Invitation for Bid No. 2025-006

Union County Sheriff's Office Fuel Station

ADDENDUM No. 2

SHERIFF'S OFFICE FUEL STATION
MONROE, NC
Consultant Project No: 2241794

E0.10

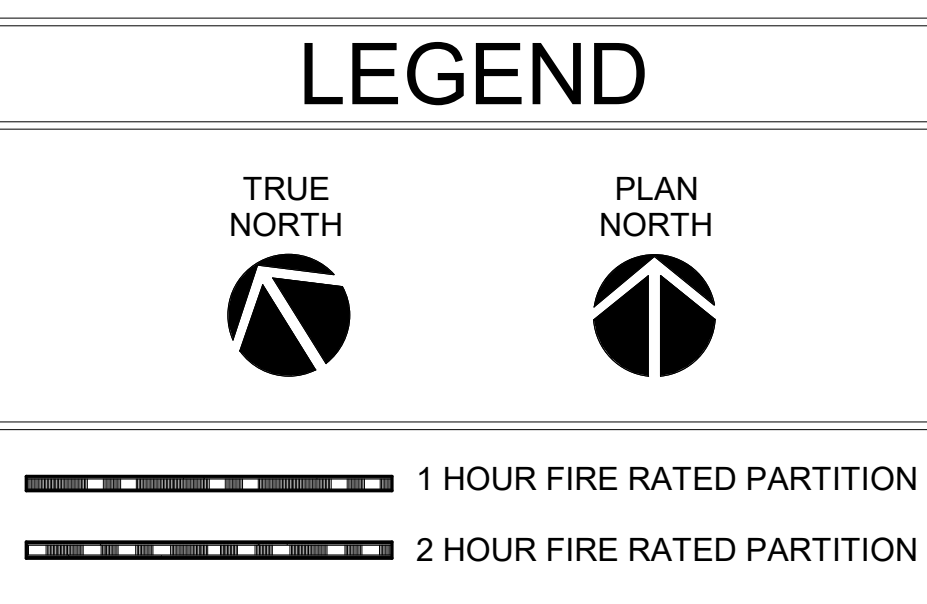
- a. If not, please provide updated drawing for concrete and privacy wall for estimating
7. Please send drawing of anticipated interior conduit path with anticipated linear footage as discussed at prebid.

12. Per review of the above plan sheet (G001). Per note Project Scope shown on the plan sheet noted above. Last item on scope list states to provide security camera for area surveillance. No specifications have been provided for this security camera. Will this be provided direct by Owner? Will we only need to provide conduit with pull string for final installation to be complete by Owner? Provide security plan sheet showing where conduits from new camera will need to be installed from starting point to final connection point.

7. Interior conduit routing plan attached for reference.
8. Extension of the bid date issued as Addendum 1,
9. Yes, lifts are acceptable to use.
10. Fuel resistant caulking added to detail on sheet A101.

12. Cameras provided by owner. Conduit and cabling provided by contractor from main electrical room to fiber cable box on fuel station enclosure. Contractor to provide conduit with pull string from cable box to fuel dispenser and camera locations. Interior conduit routing plan attached for reference.

A101

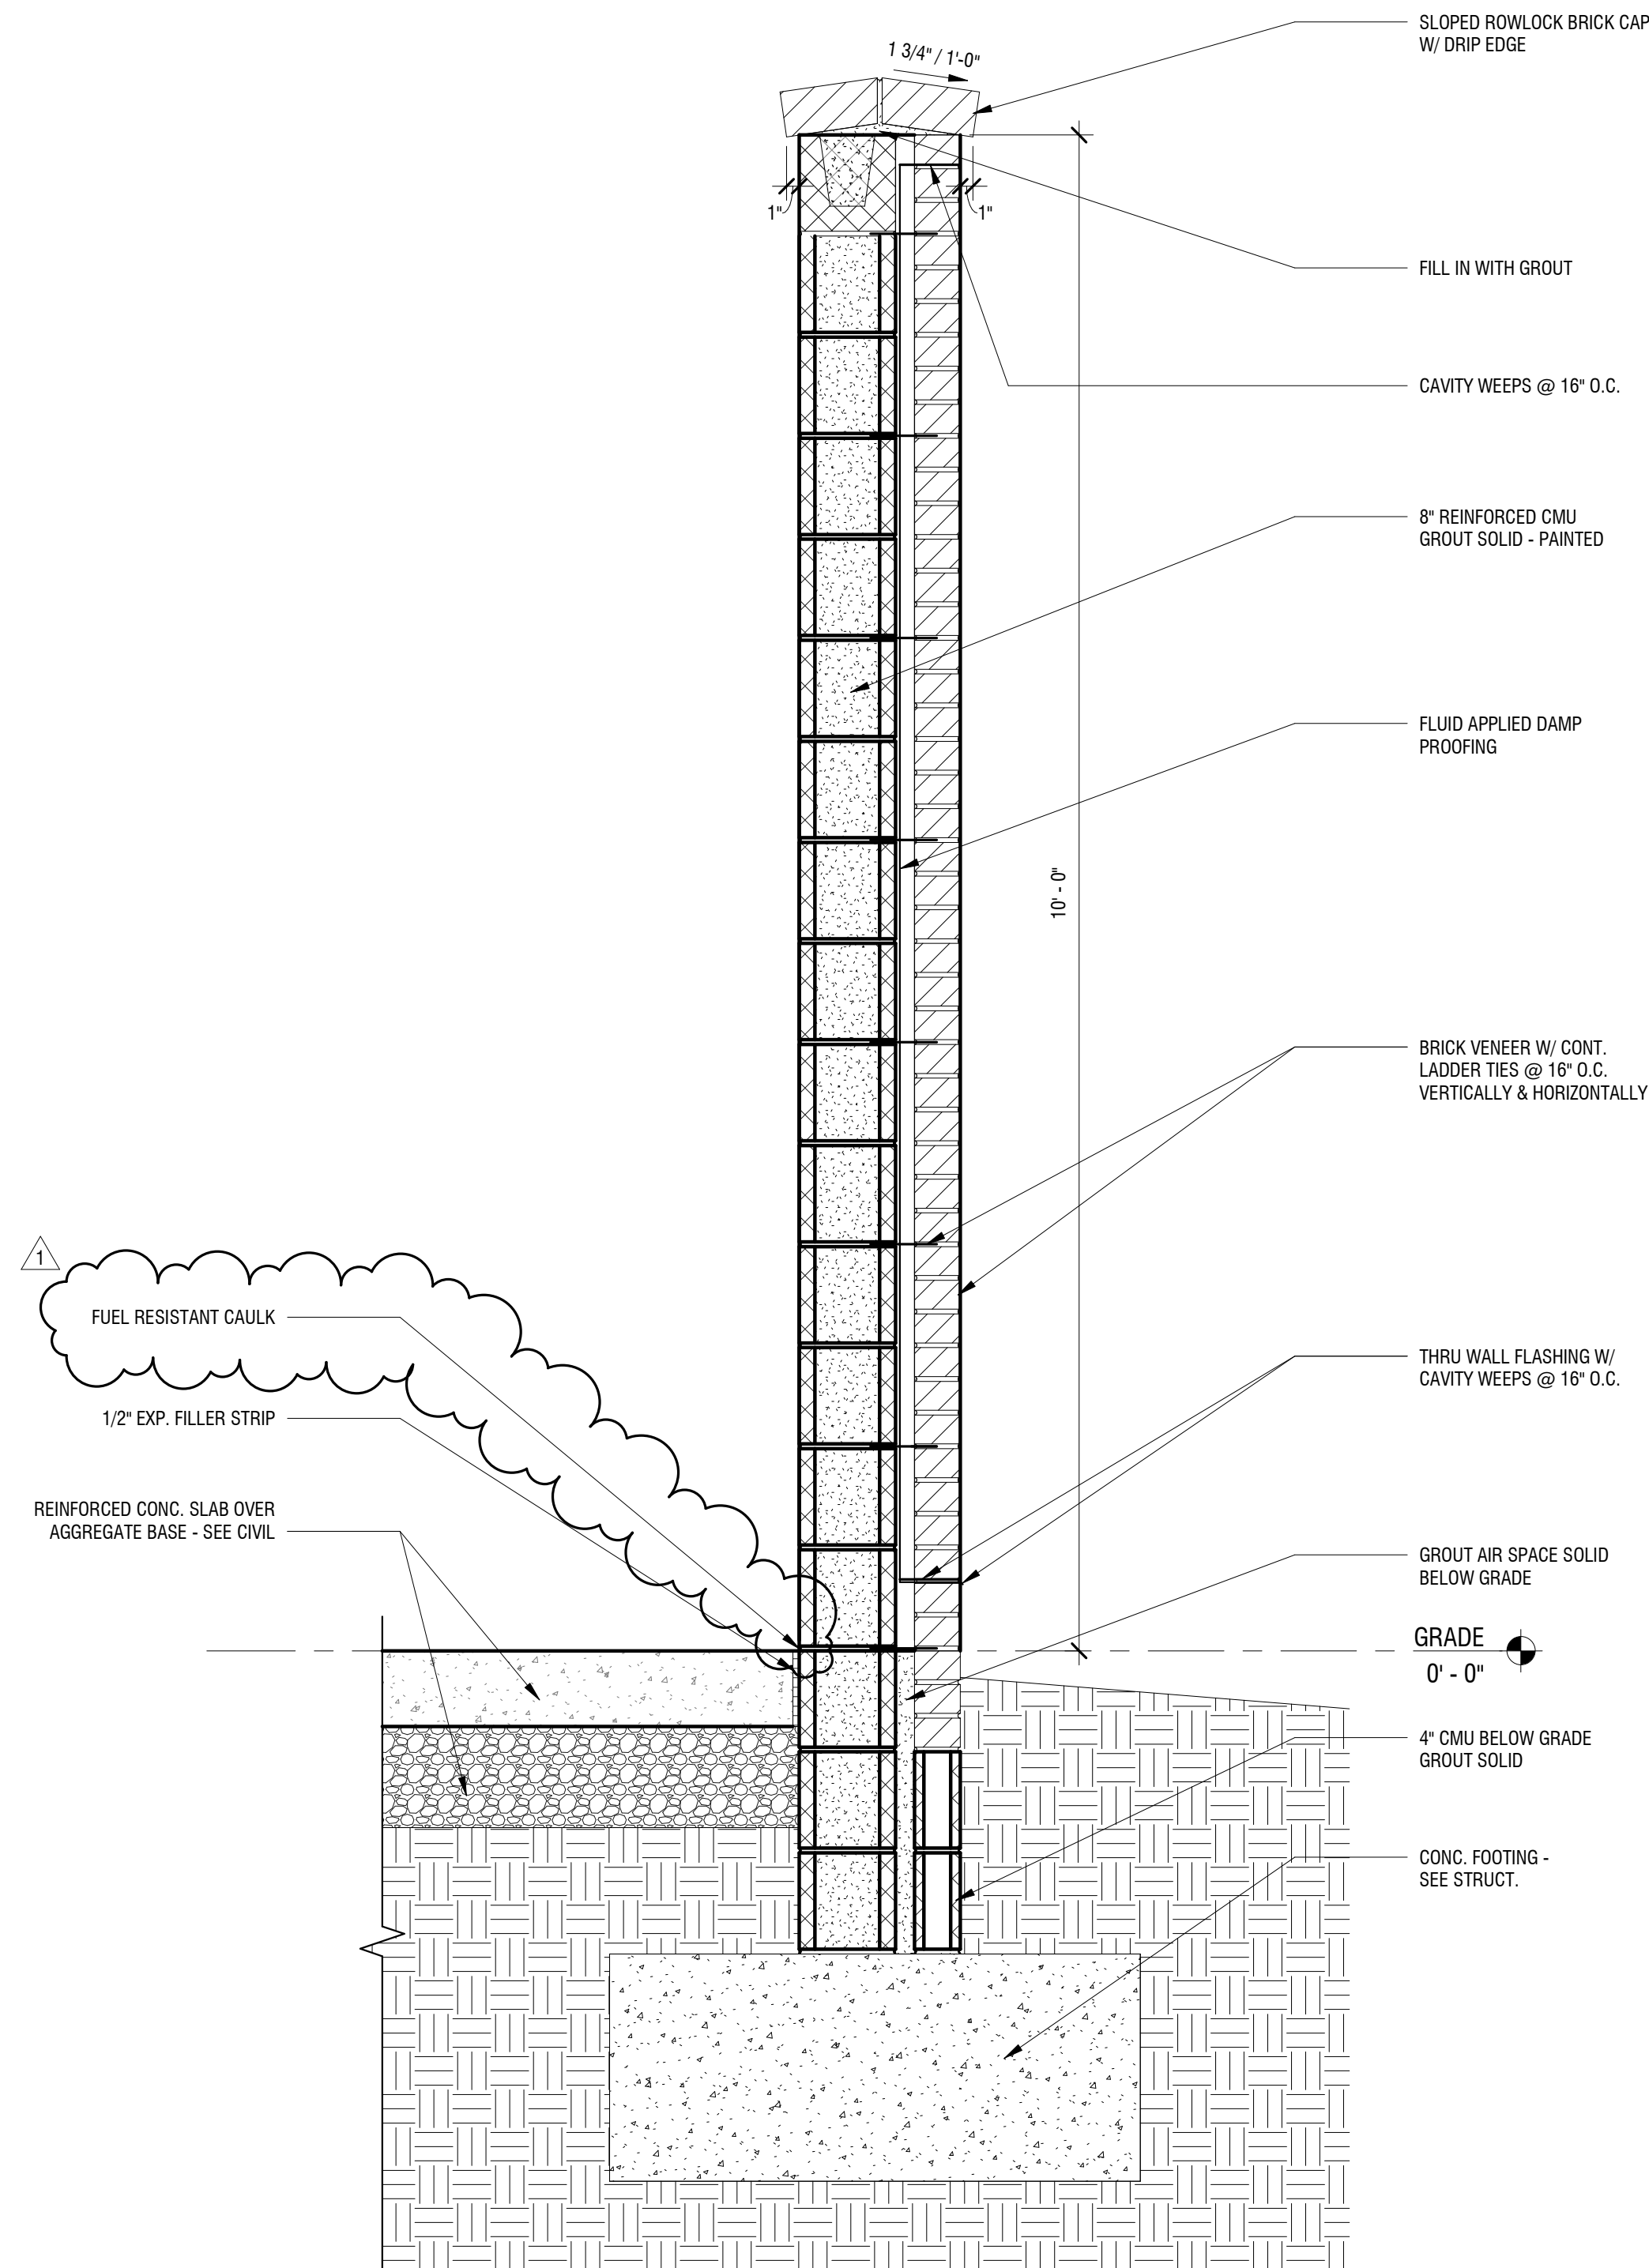
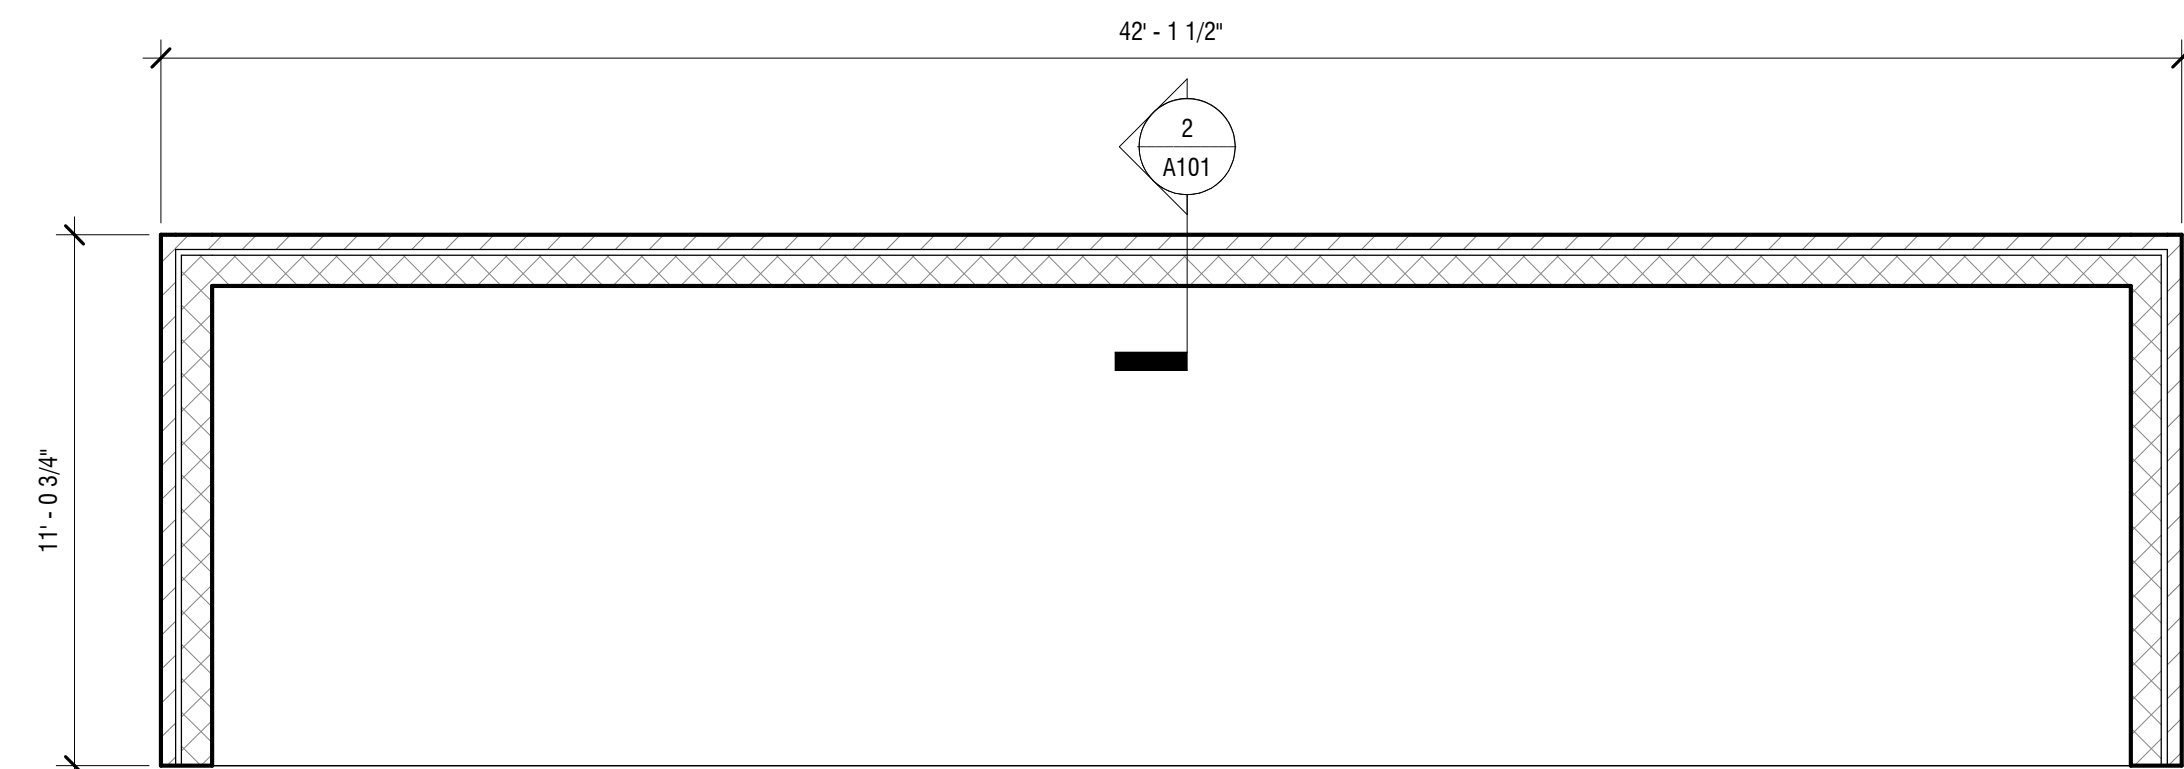
10. Per review of the above plan sheet. No Fuel resistant caulking as been shown to be installed around top of expansion joint materials around the bottom of the new concrete slab where it butts up to new CMU walls. Review this issue and confirm if this will be required.

11. Per review of the above plan sheet. "8" Reinforced CMU Grout Solid-Painted" No paint specifications have been provided on plans or specifications for these CMU walls. Provide paint specifications for the paint for these CMU walls so it can be priced correctly.

13. Per review of the above plan sheet (A101). Please provide specifications on the existing brick that was used for the new Sheriff's office so correct masonry materials can be priced to match existing brick materials.

11. Provide 1 coat of primer, Sherwin Williams Pro Industrial Block Filler (Sales # 650515430), and two coats of Sherwin Williams, Loxon Self Cleaning Satin – Network Grey paint

13. Brick: Palmetto Brick - Chocolate Wirecut; Mortar: Holcim Type N
